COMMUNITY DEVELOPMENT DEPARTMENT REPORT

SUBJECT: H-2024-0073
PAW Subdivision

LOCATION: 1680 W. Ustick Road
Located in the SE ¼ of the SE ¼ of
Section 35 T. 4N, R.1W, Parcel No.
S0435449705

D. Preliminary Plat (date: 9/22/2021)

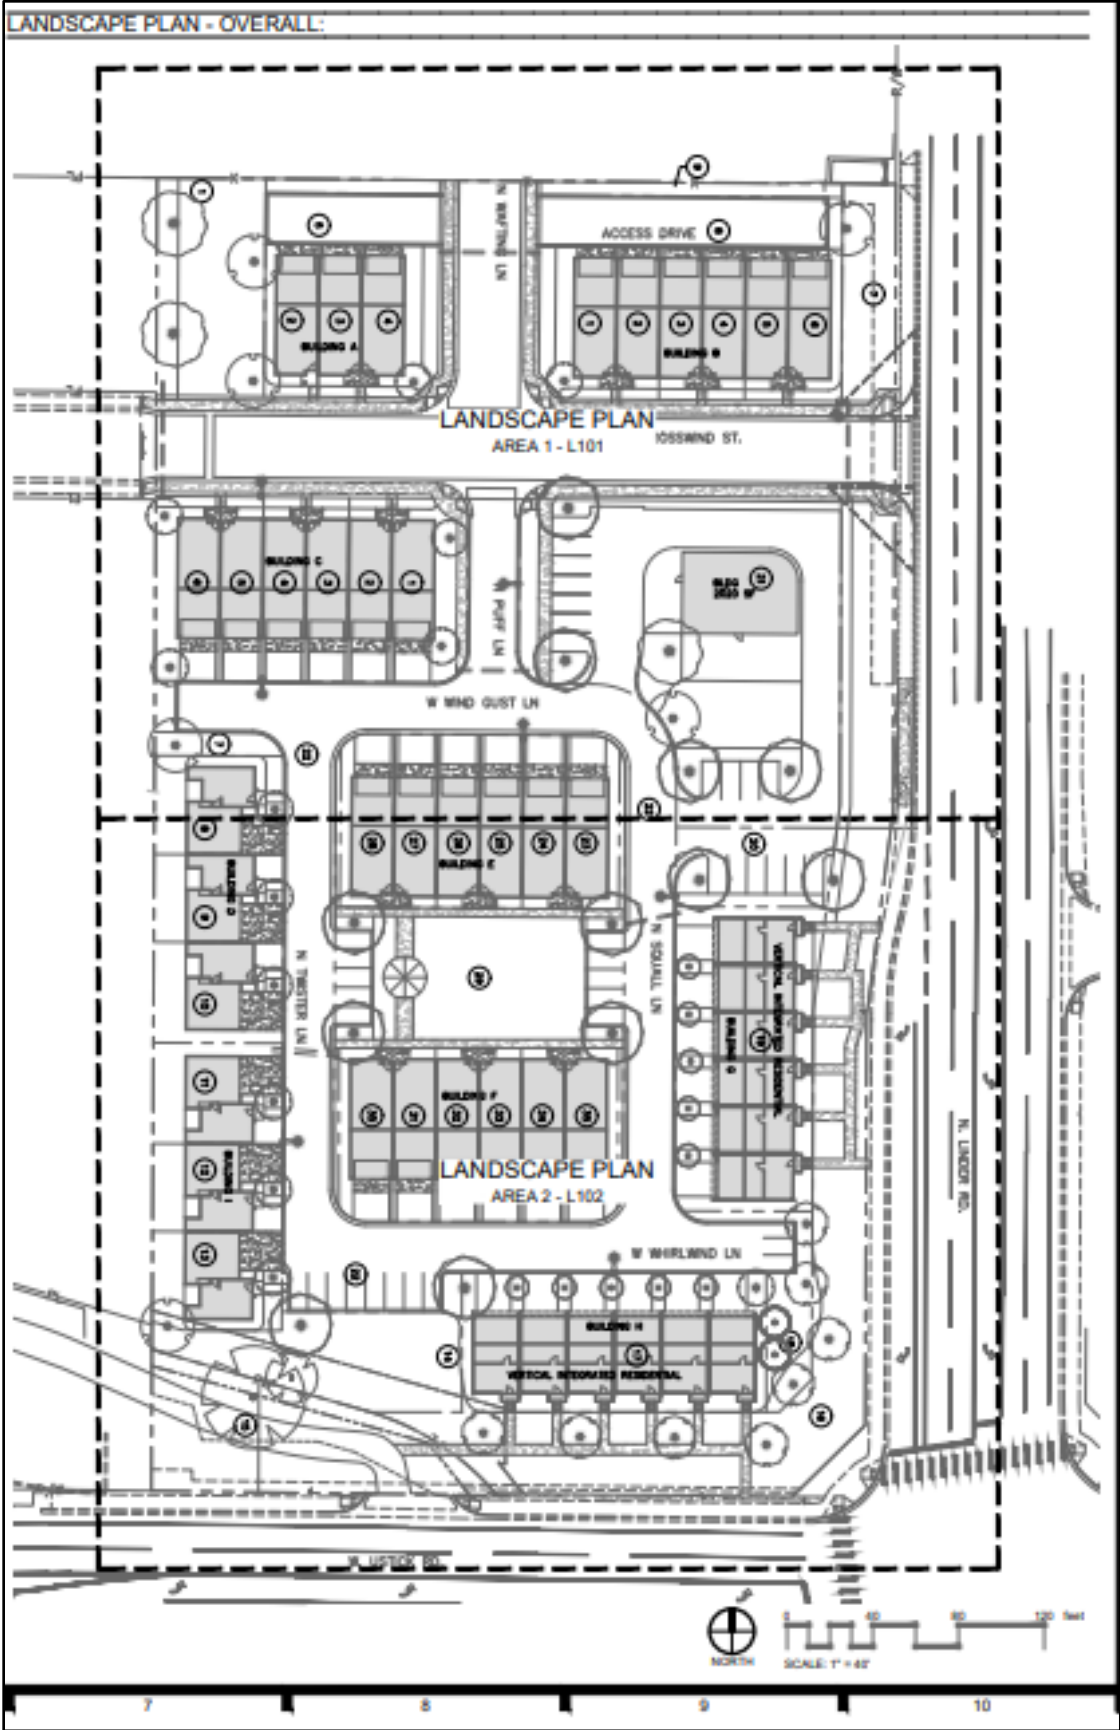
13. The preliminary plat dated 3/04/2025, shall be revised as follows:
 - a. Per UDC 11-3B-7, all arterial street buffers shall be on a common lot or on a permanent dedicated buffer, maintained by the property owner or business owners' association.

- b. Residential street buffers shall be on a common lot, maintained by a homeowners' association.
 - c. Identify the common lots within the notes on the plat.

E. Landscape Plan (date: 11/30/2022)

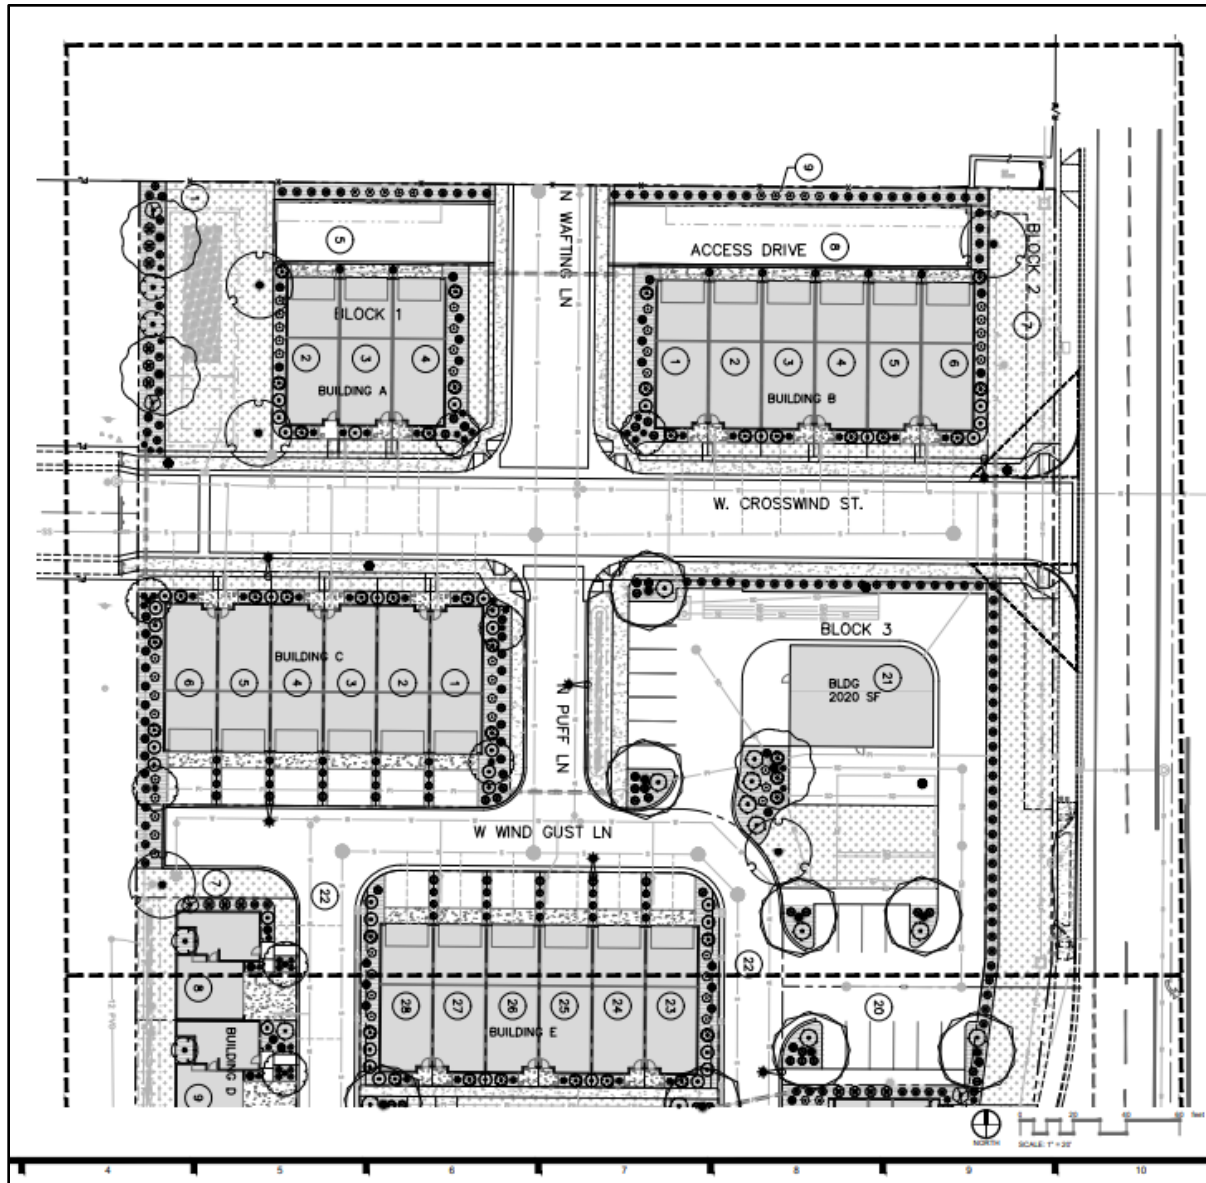
However, it does not appear either landscape buffer meets the minimum landscaping standards of at least one tree per every thirty-five (35) linear feet. as there are long sections of arterial buffer without trees. A total of eighteen (18) trees are required along Linder Road. The applicant will need to revise the landscape plan to include the additional trees.

14. The landscape plan dated 3/04/2025, shall be revised as follows:
 - a. Based on the thirty-eight (38) parking spaces provided, a total of two (2) bicycle parking spaces is required. The location of the bicycle racks will need to be depicted on the site and landscape plans. An example of the bicycle rack will be required to be submitted with the CZC for review and approval.

- b. The landscape plan shall show any proposed fencing for the development with a detail of the fencing being proposed.
 - c. The landscape plan shall provide the minimum density of one (1) tree per thirty-five (35) linear feet is required for street buffers per UDC 11-3B-7.

- d. Apply the 10-foot landscape buffer along W. Crosswind Street in the location of the commercial pad.
 - e. Per UDC 11-3B-10, a mitigation section shall be added to the landscape plan for trees that are removed from the site that are four-inch caliper or greater.
